**PLAN COMMISSION
AGENDA**

**Wednesday, May 18, 2016
7:00 PM
City Council Chambers - First Floor**

DATE: May 13, 2016
TO: Plan Commission
FROM: Drew Rackow AICP, Planner
SUBJECT: Design Review: Suncast Building Expansion – 1801 Suncast Lane
Mackie Consultants on behalf of Suncast Corporation, Applicant

DATE: May 13, 2016
TO: Plan Commission
FROM: Drew Rackow AICP, Planner
SUBJECT: **Administrative Design Review for Tanglewood Hills Unit 5 Landscape Revisions**
Toll IL IV LP., applicant

SHEET TITLE
BUILDING ELEVATIONS

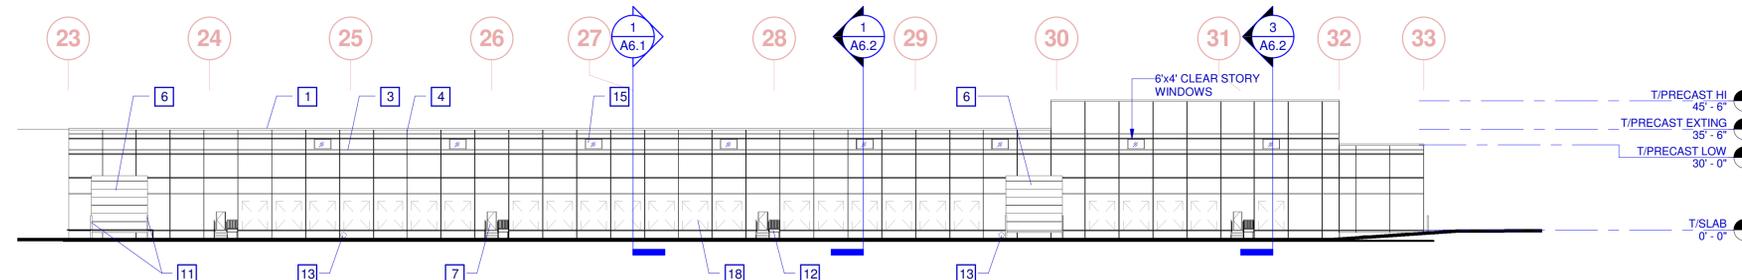
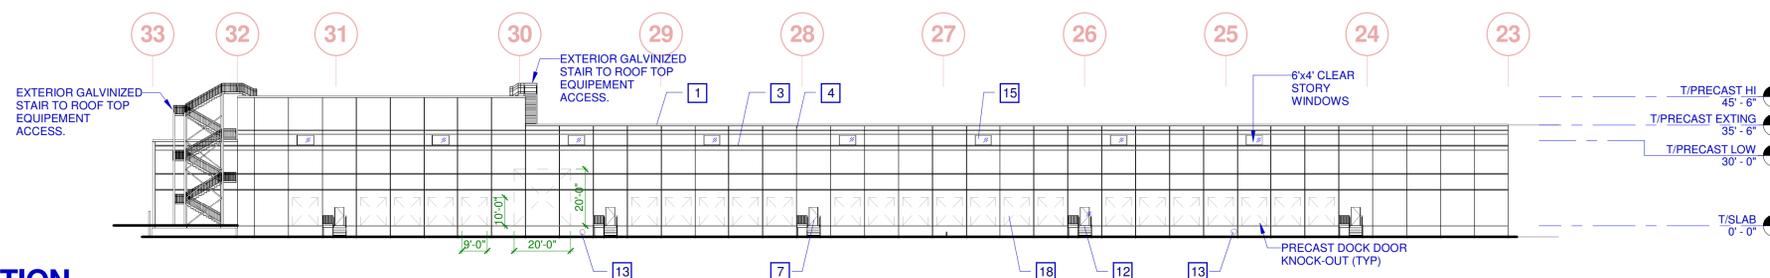
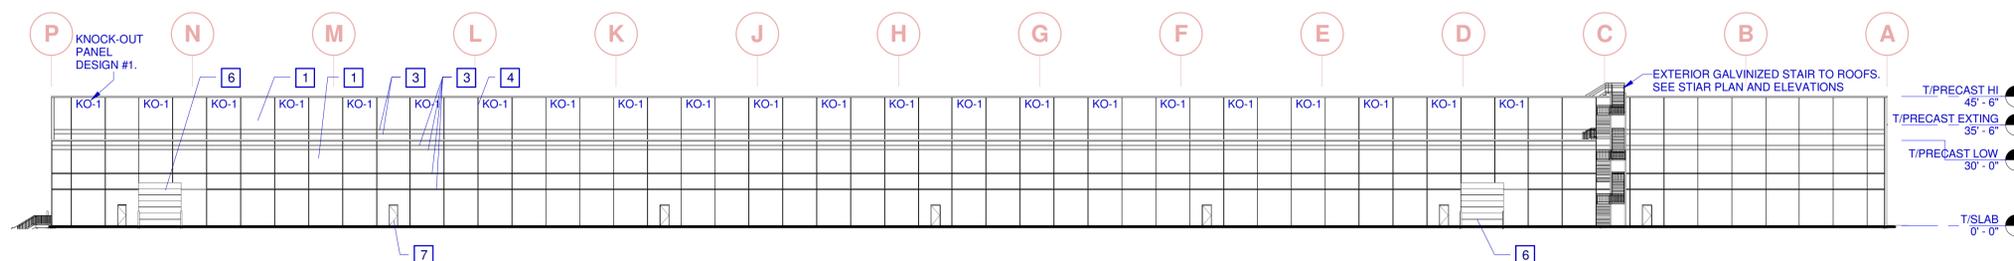
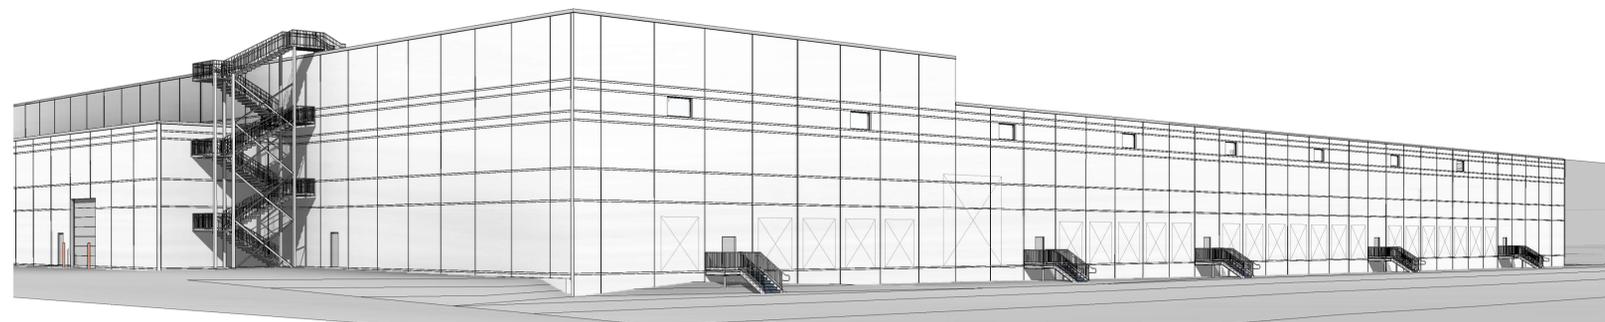
General/Building/Setbacks: The application depicts a building designed in a manner to be reflective of the existing structure. The architecture and design continue the patterns and design of the existing structure. The proposed building and perimeter landscape areas meet the Zoning Code requirements. A staircase is provided at the southeast corner of the building to provide access to rooftop equipment. New operations will require more frequent access to this portion of the building, requiring a staircase rather than a ladder system. Locations have been indicated for a silo structure to provide raw material along the western edge of the property near the railroad.

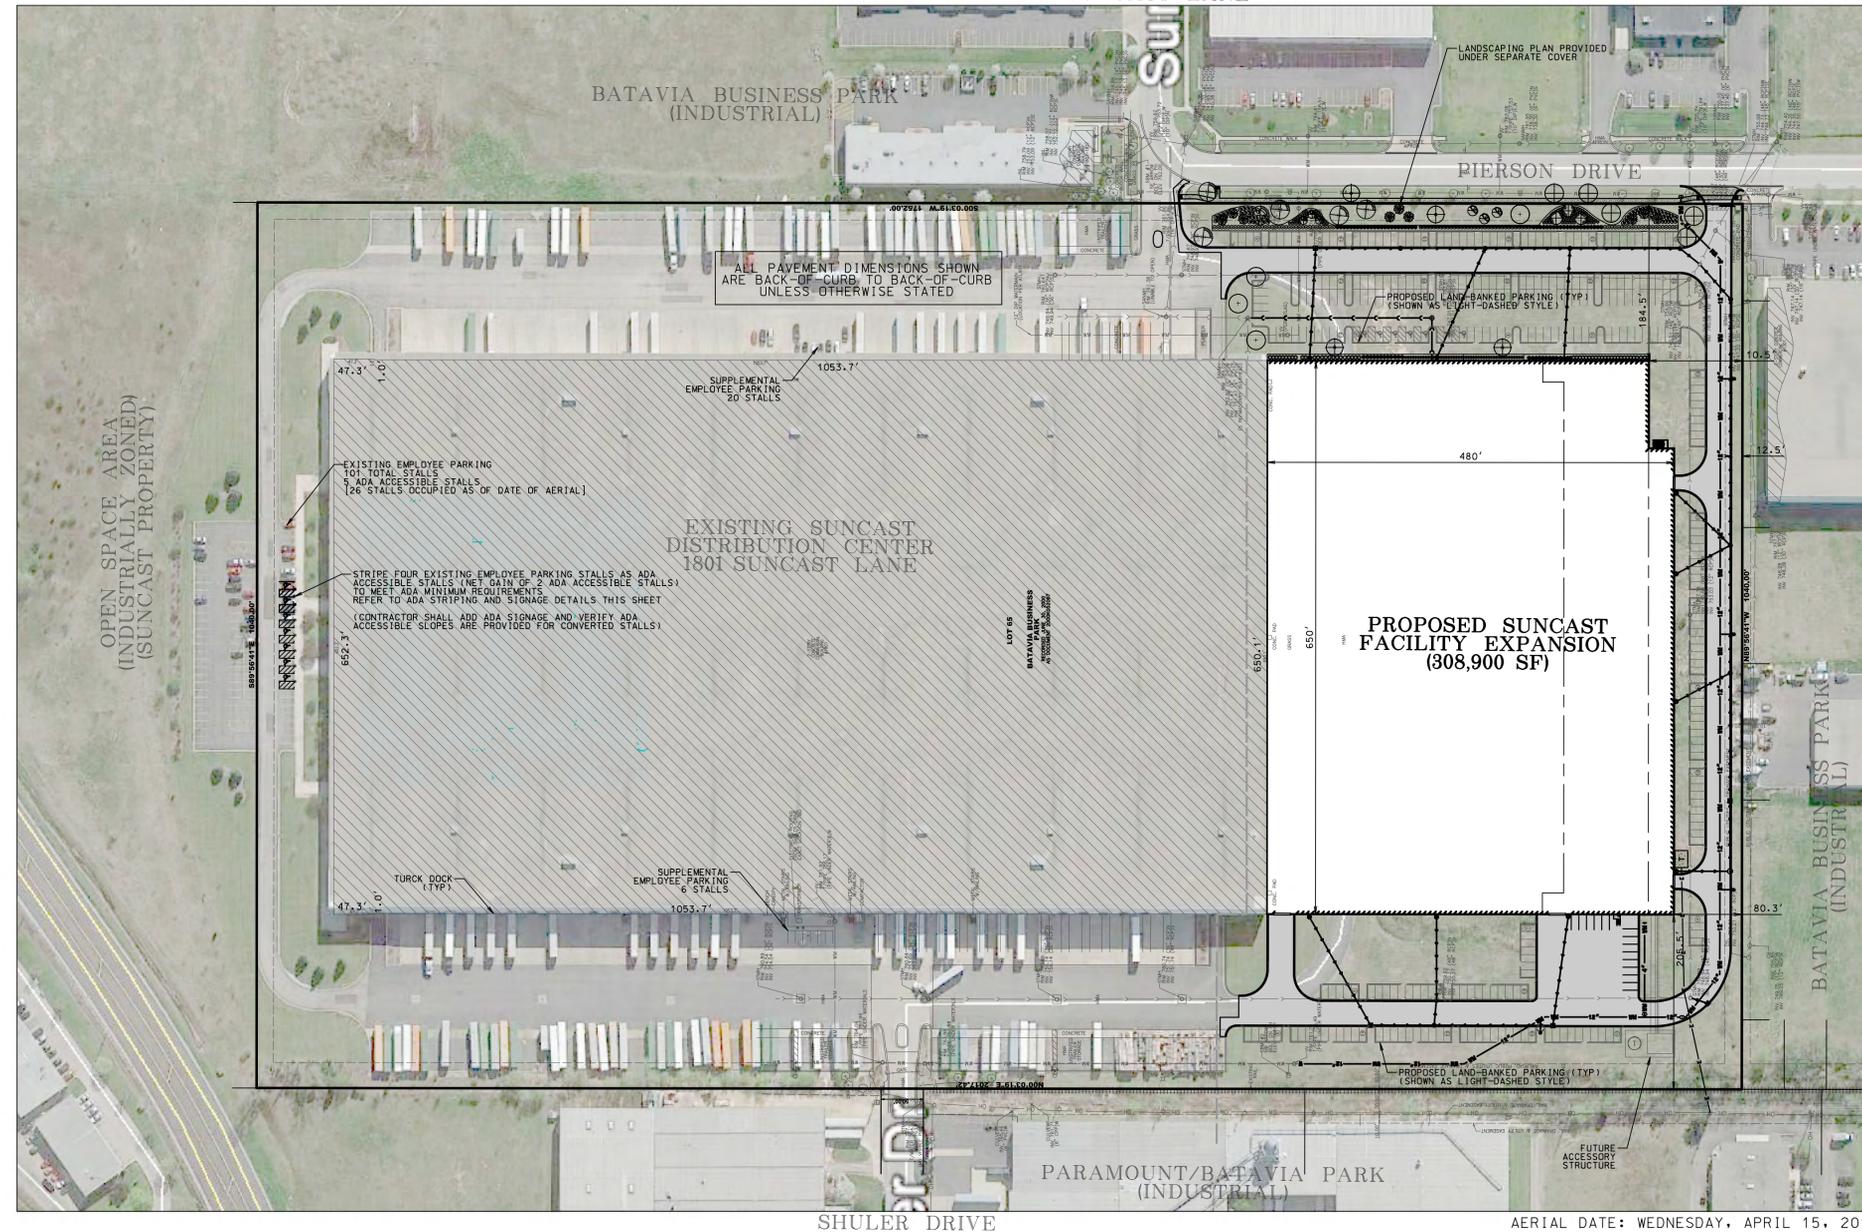
In order to allow the provided parking in the amounts depicted as landbanked a variance would need to be sought to increase the allowed percentage of landbanked spaces. Staff would support a variance to increase the amount of landbanked spaces from the maximum allowed 187 spaces (50%) to 361 spaces (96.5%) required by the addition. Staff would recommend a condition of approval for modification of the proposed parking lot at the southwest corner to conform to Section 4.2 of the Zoning Code. In the absence of a variance, only 187 spaces may be landbanked. Staff would recommend a condition of approval requiring either 1) 187 spaces be constructed prior to occupancy, 2) a variance is granted to increase the amount of landbanked parking to 361 spaces (96.5%) prior to occupancy, or 3) that a letter of credit or acceptable surety be submitted guaranteeing the construction of the spaces if zoning relief is not granted prior to occupancy.

LANDSCAPE PLAN
TANGLEWOOD HILLS - UNIT 5
 CITY OF BATAVIA, KANE COUNTY, ILLINOIS

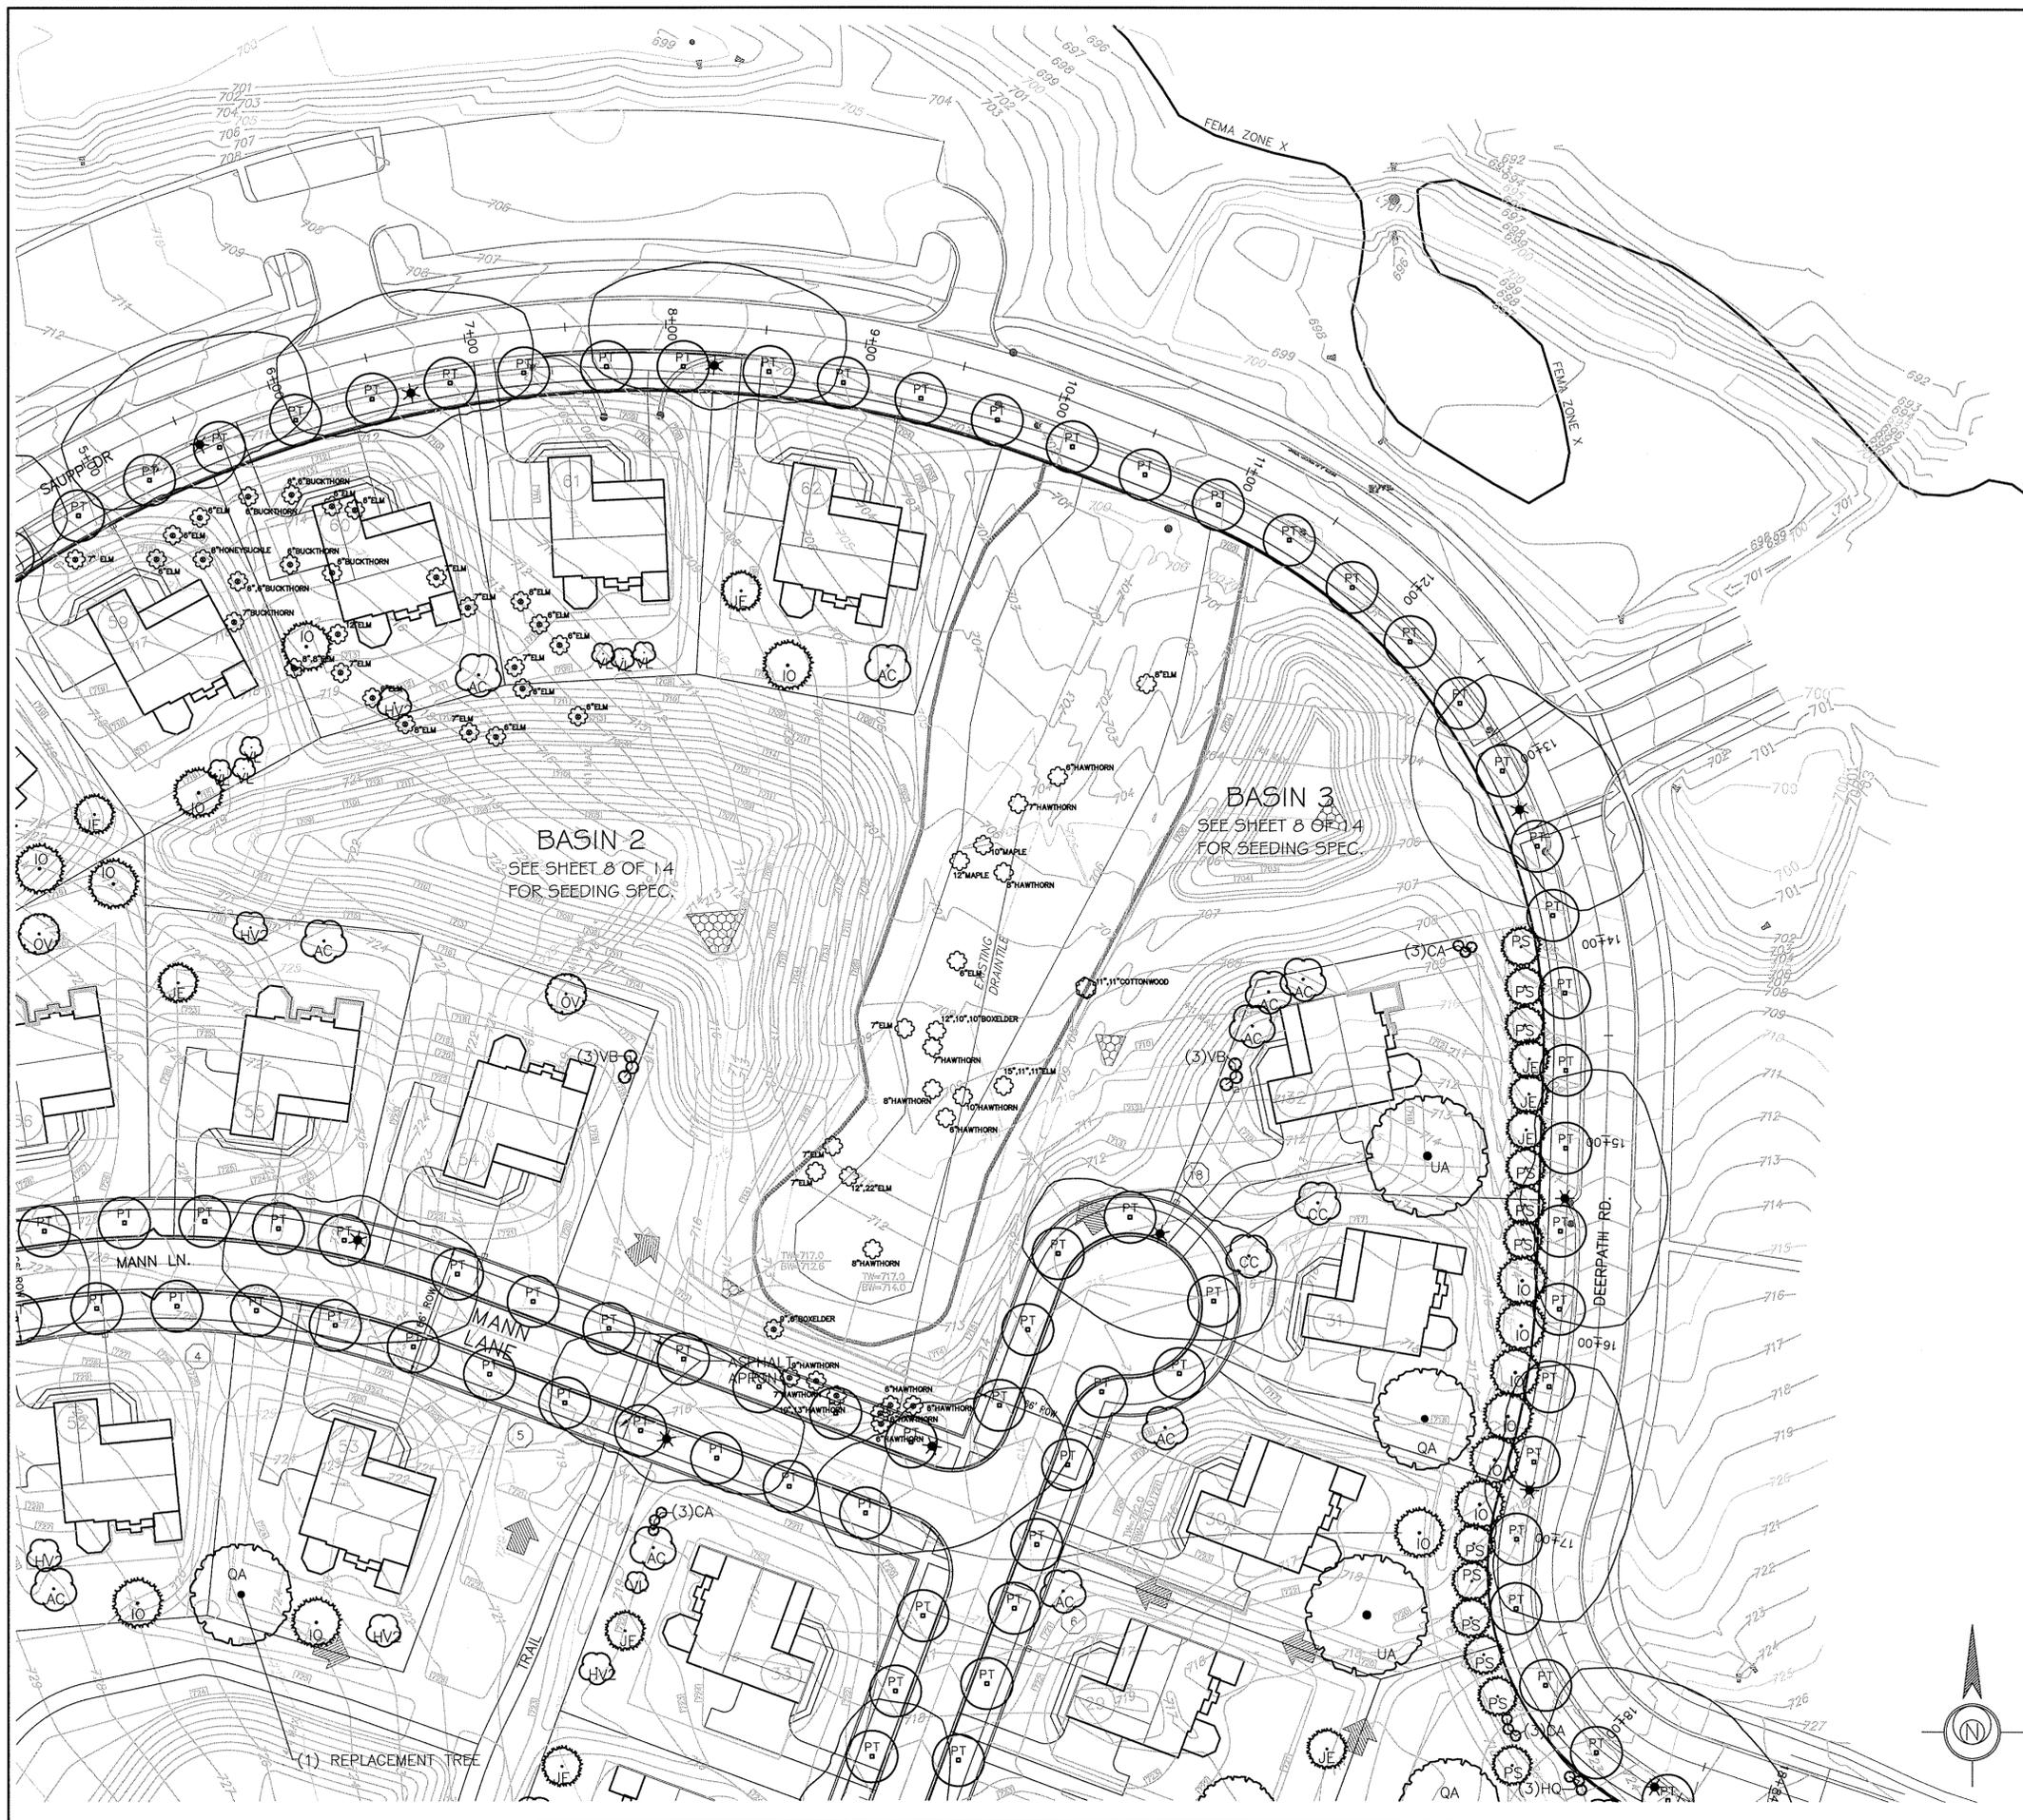
1. Relocate trees from the Common Open Space areas onto private lots. The number of plantings would be maintained, and agreements would be in place to allow the HOA to require landscape maintenance on the back of the private lots. This would allow the open areas to remain more prairie-like similar to the other units.
2. Modification of the Common Open Space Landscape plan to remove areas of turf grass and certain other specifics from the seed mix, similar to the other units.
3. Paths would be composed of crushed limestone rather be paved. Connections within the right of way would be paved.
4. Path at Mann/Josyln Court to Limestone would be removed. The City would mark a bike route down Mann Lane to reconnect to the Nicor Trail and Deerpath Road via Limestone Drive.
5. Removal of the Common Area fence on lots 30-32. This was to be a stockade fence.

The proposed landscape and site changes would still maintain current quantities and levels of landscaping. The proposed modifications would better align the open space of Unit 5 with the original open space elements of the subdivision. The changes would reduce the amount of turf grass in the open space, and put planting varieties in line with the HOA's current planting program. The bulk of the relocated plantings would be to private lots, where covenants would give the HOA the authority to require the plantings' maintenance. The revised landscape selections would maintain a reasonable variety of. The HOA would prefer to not have a fence along lots 30-32 and instead have the landscaping provide a buffer to the homes along Deerpath Road. Staff believes this too is an appropriate change, as the stockade fence was approved subject to HOA design requirements. Staff believes the significant landscaping will provide a uniform appearance along Deerpath Road.
